**Grant County**  
**Central Services**  
P O Box 37  
Ephrata WA 98823  
(509) 754-2011 Ext-3276

All perspective bidders  
Subj: Addendum #1CSD1913 Ardell Fire Suppression

June 19, 2019

The addendum noted as “AD1-E1” shows an updated electrical plan and added notes in this area. It reflects rerouting of the conduit around this room.

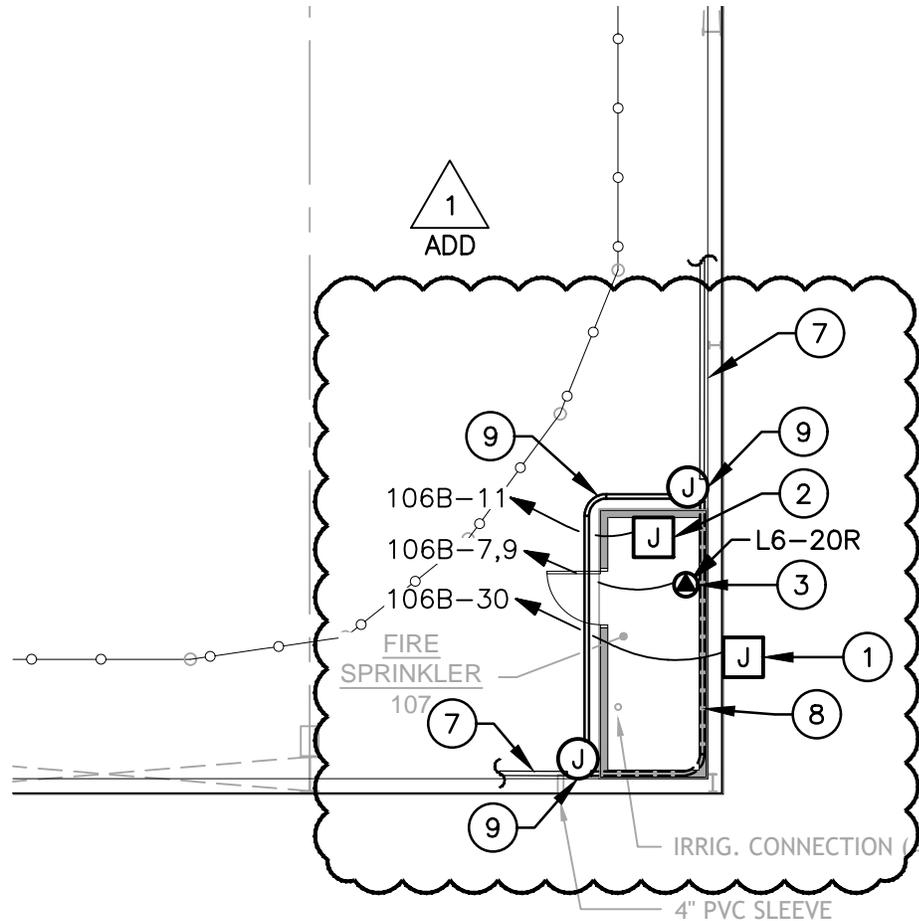
The architect has sent out an addendum regarding page E1. It was discovered that there is a conduit feeding emergency lighting running along the wall in the area where the riser room is to be constructed.

7. EXISTING CONDUIT AND CONDUCTORS ROUTED ALONG EXISTING WALL.
8. REMOVE EXISTING CONDUIT AND CONDUCTORS WHICH ARE ROUTED THROUGH NEW FIRE SPRINKLER SPACE.
9. REROUTE CONDUIT AND CONDUCTORS, AT NEW FIRE SPRINKLER ROOM TO OUTSIDE OF NEW SPACE. MAINTAIN EXISTING CIRCUIT, EXTEND CONDUIT AND CONDUCTORS AS REQUIRED.
